Condition 109	Roadway Safety Analysis
<p>Prior to commencing construction activities at the Giacomazzi site, the applicant shall submit to the Department of Public Works for review and approval a Roadway Safety Analysis (RSA) for the intersection of the treatment plant access road with Los Osos Valley Road. The RSA shall be prepared by a registered civil engineer with expertise in transportation design and familiarity with the Los Osos Valley Road corridor, and shall include but not be limited to the following:</p> <ul style="list-style-type: none"><li>a) Evaluate the proximity of the cemetery access road with the project access road and discuss corrective options including realignment, road mergers (sharing) and alternative project access road locations;</li><li>b) Analyze the project access road sight distance with respect to Los Osos Valley Road and recommend improvements, if required;</li><li>c) Analyze Los Osos Valley Road left turn lane warrants and traffic queuing at the project access road and recommend improvements, if required;</li><li>d) Evaluate Los Osos Valley Road traffic safety a minimum of 1-mile either side of the treatment plant access road and provide recommendat

Exhibit - Existing Conditions  
10/27/2010

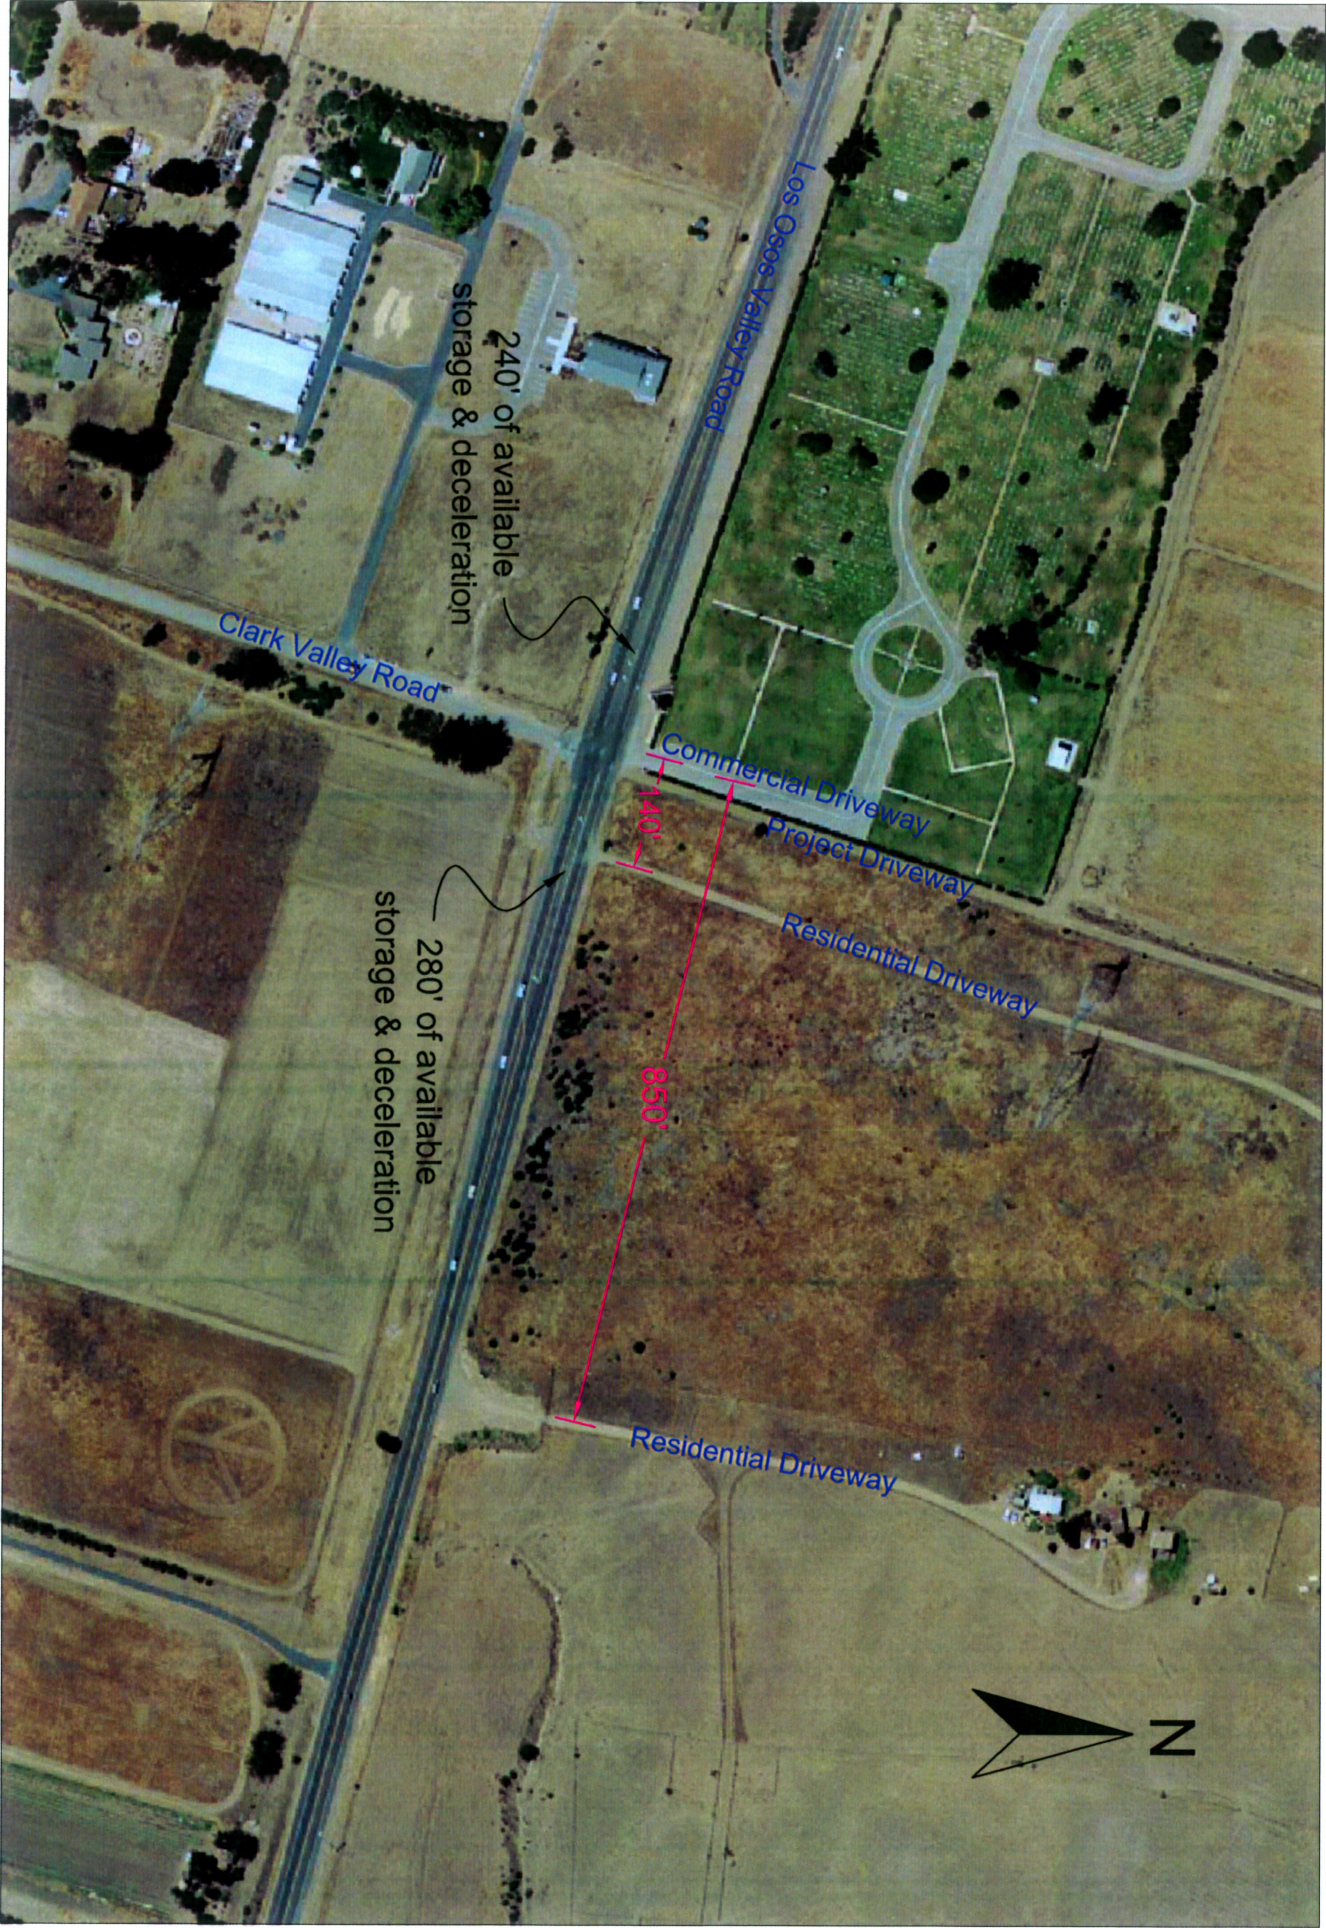
LOVR is a two lane arterial with 4 to 8 foot wide class II bicycle lanes attached. There is a dedicated left turn lane for the intersection of Clarke Valley Road on the southerly side of the road and three driveways on the north side, the Cemetery driveway, a gravel driveway currently accessing the project site, and a residential driveway 140 feet east of the intersection. The attached exhibit details the existing geometric conditions.

Currently there are 4 access points onto Los Osos Valley Road within a 150 foot distance. The County Standards (section 4.1.5 E) state that entrances on Arterial roadways should be 200 feet away from the roadway. To accommodate this distance the following would have to occur:

In conjunction with the driveway spacing there are operational impacts caused by offsetting the entrance on LOVR across from Clark Valley Road. A large offset can create additional conflict areas for turning traffic and cause head on accidents for traffic passing through the intersection. In this case, the estimated traffic driving from Clark Valley Road to the entrance is low so the left turn conflicts govern the intersection

Any offset should be made as small as possible and can not be greater than 16 feet. This can be accomplished by either partially reconstructing the intersection of Clarke Valley Road or relocating the entrance per option 2. A topographical survey and preliminary design should be performed to verify the proposed alignments intersection offset is within these limits.

1. Increase the length of the left turn storage and deceleration lane to 535 feet for the westerly approach of Los Osos Valley Road.
2. Combine the three entrances on the north side of the road into a single shared entrance.
3. Eliminate or minimize the intersection offset between Clark Valley Road and the entrance.
